Sub: Technical Advisory Note for System improvement regarding installation for Stationary KAVACH (Train Collision Avoidance System).

| TECHNICAL ADVISORY NOTE | | | | |
| Subject | System Improvements regarding Installation and Maintenance for KAVACH | | | |

Sub: Approval of fitment of RFID Tags in CC apron area of station in TCAS installation station.

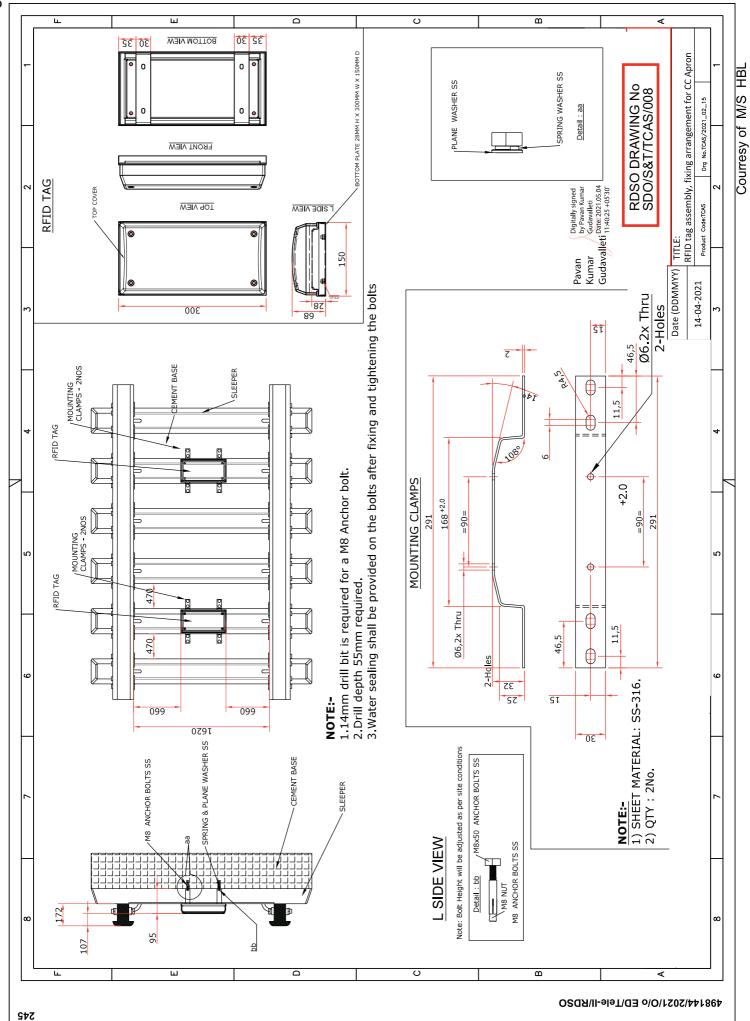
With reference to above, a schematic drawing showing the fitment of RFID tags in CC Apron was sent by Signal Dte for examination and approval from Track Dte (ref-i). The drawing was examined and the deficiencies were communicated vide this office note under ref-ii.

In response, Signal Dte, submitted a revised drawing (ref-iii), which was examined by Track Dte (unit-III) and accordingly it is communicated that Track Design Dte has no objection to the proposed fixing arrangement of RFID tags in CC Apron area using mounting clamps, as shown in the drawing no. TCAS/2021_02_15 dated 14.04.2021 duly approved by ED/Tele-II on 04.05.2021 (submitted vide ref-iii), subject to fulfillment of conditions laid down in the joint minutes of meeting held on 27.08.2015 on similar subject as applicable (ref-iv). It should also be ensured that there is no infringement to Max. moving dimensions / IRSOD due to the proposed installation .
